# MICROCHIP PIC16F631/677/685/687/689/690

## PIC16F631/677/685/687/689/690 Rev. A Silicon/Data Sheet Errata

The PIC16F631/677/685/687/689/690 parts you have received conform functionally to the Device Data Sheet (DS41262D), except for the anomalies described below.

**FIGURE 8-2: COMPARATOR C1 SIMPLIFIED BLOCK DIAGRAM**

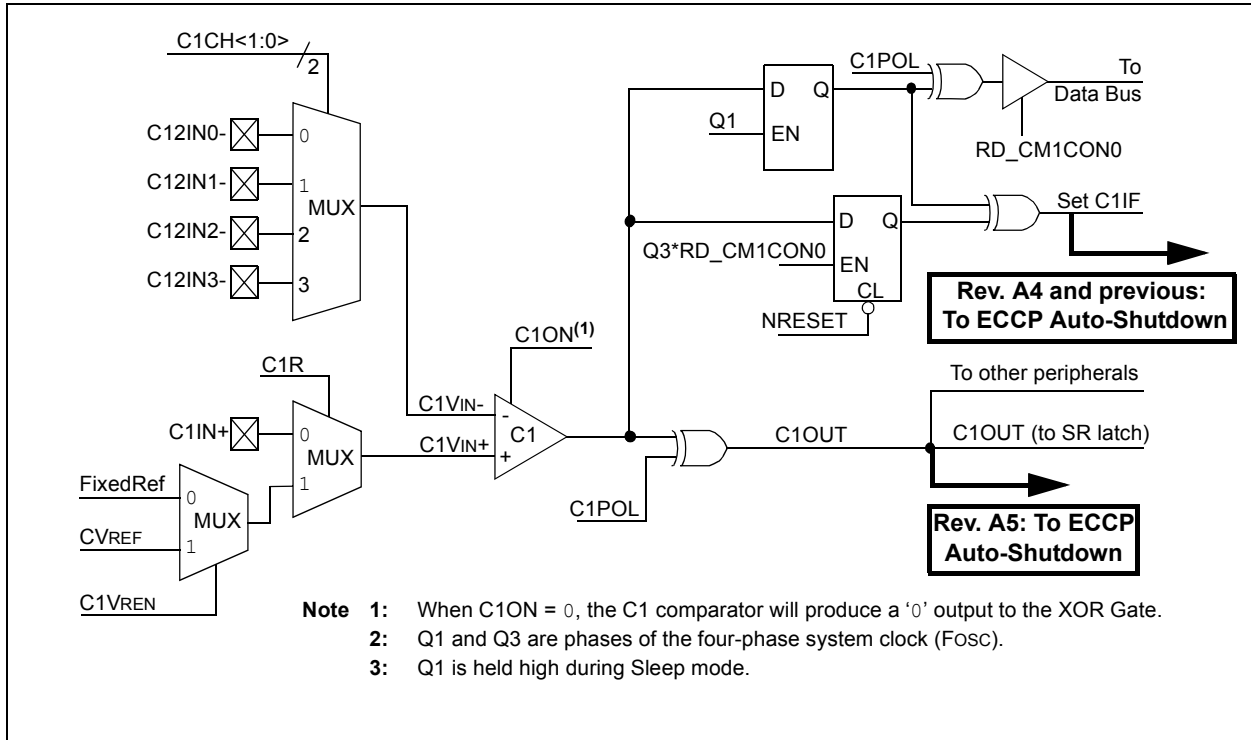
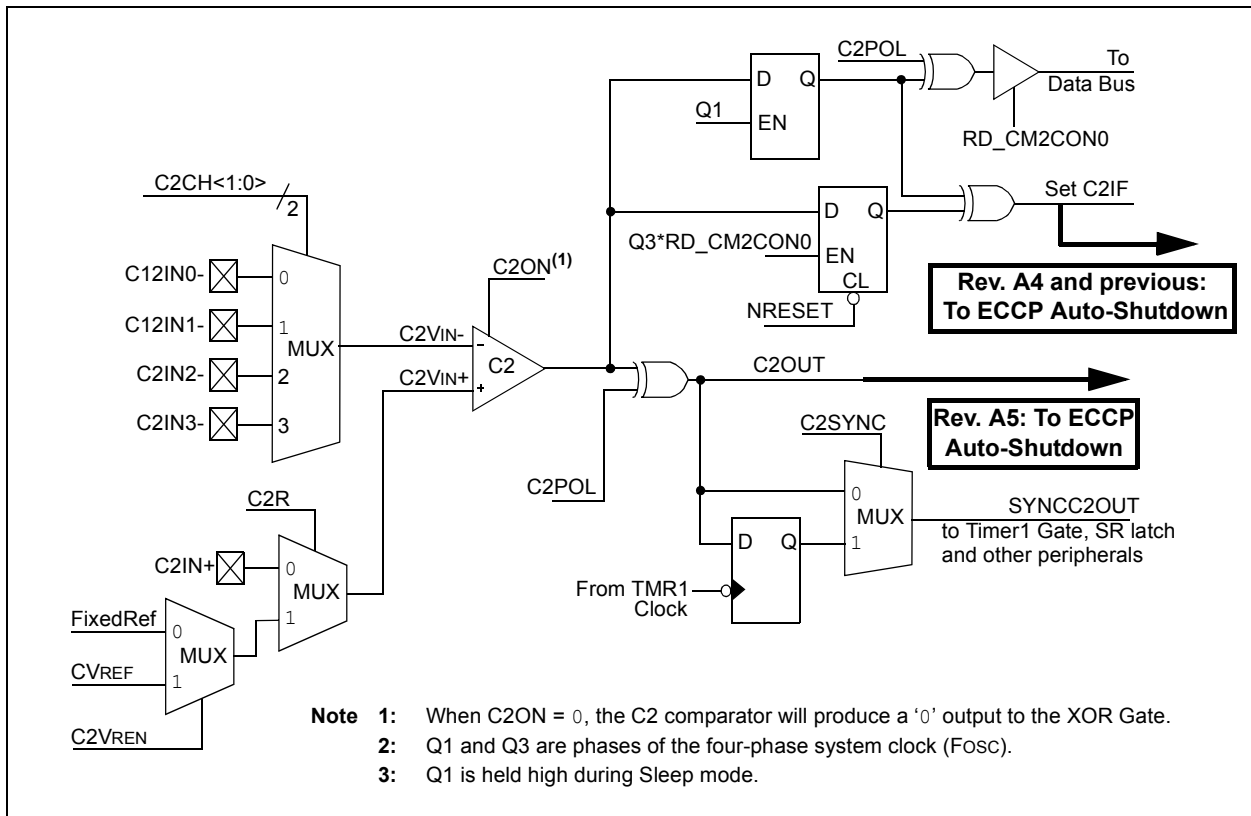
The PIC16F631/677/685/687/689/690 Rev. A4 silicon for the ECCP auto-shutdown is connected to the C1IF and C2IF flags. See Figures 8-2 and 8-3 on the following page.

The auto-shutdown connection (Rev. A4 and previous) to C1IF and C2IF causes the auto-shutdown to incorrectly operate synchronously. Additionally, reads of CMxCON0 will incorrectly clear an auto-shutdown event.

- 1) Poll the CxOUT bit until it is low.
- 2) Read CMxCON0 to precondition CxIF.
- 3) If CMxCON0 is read while CxOUT is changing, repeat steps 1 and 2.

**FIGURE 1: SILICON REVISION A4 AND PREVIOUS VS. REVISION A5**

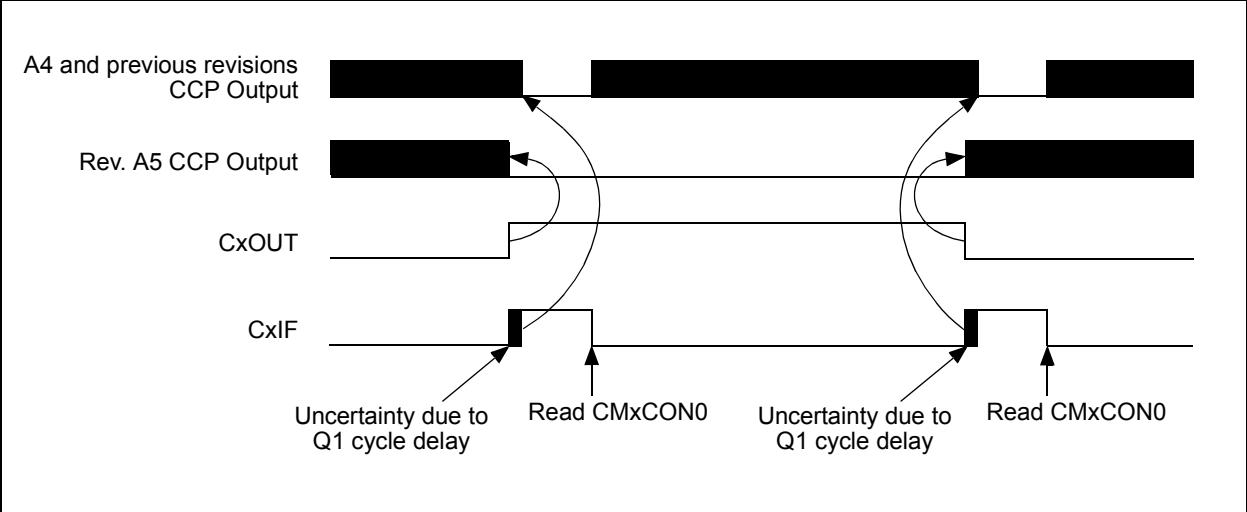
The Silicon Rev. A5 (now shipping) and later revision devices have moved the auto-shutdown connection from CxIF to CxOUT. This will eliminate the synchronous shutdown and simplify the use of the comparator for a shutdown event. Figure 1 shows the function of auto-shutdown before and after the device revision.
